113061 - 00

Change Notification #: 113061 - 00
Change Title: Intel® Server System R1304BB4GS9
PCN 113061-00, Product Design
Update System PSU Bracket and Add Mylar
Bumper
Date of Publication: June 13, 2014

Intel is implementing the following changes on Intel® Server System R1304BB4GS9:

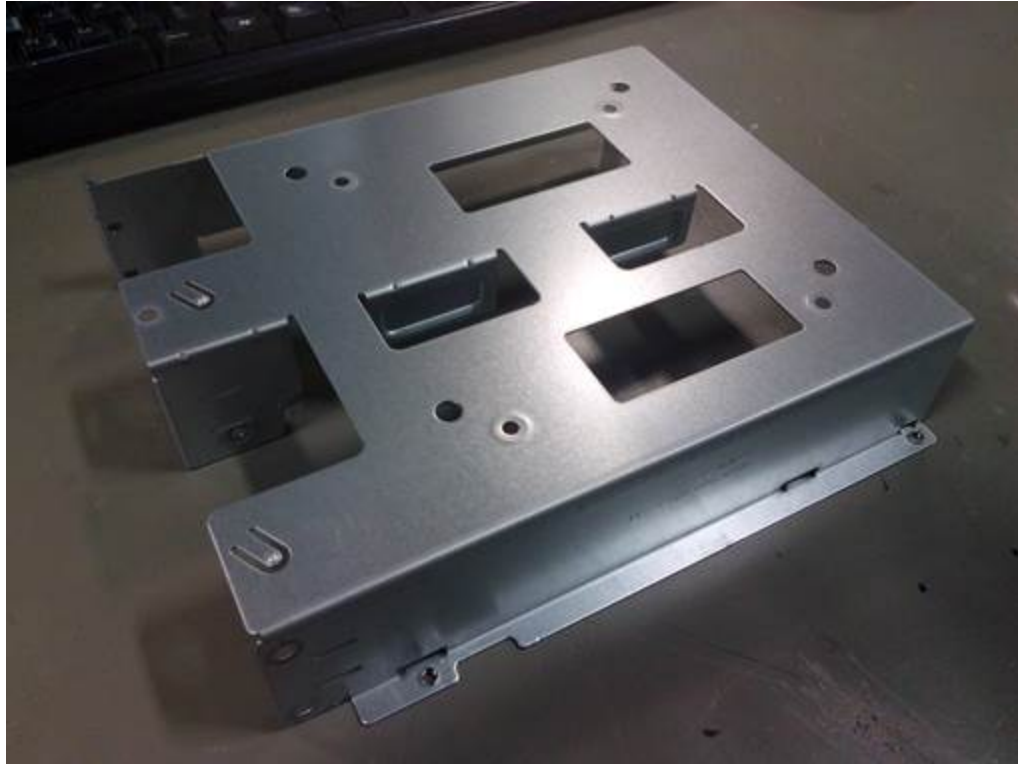
1. Update the Power Supply bracket by removing the middle punch. Please refer to the following pictures for details:
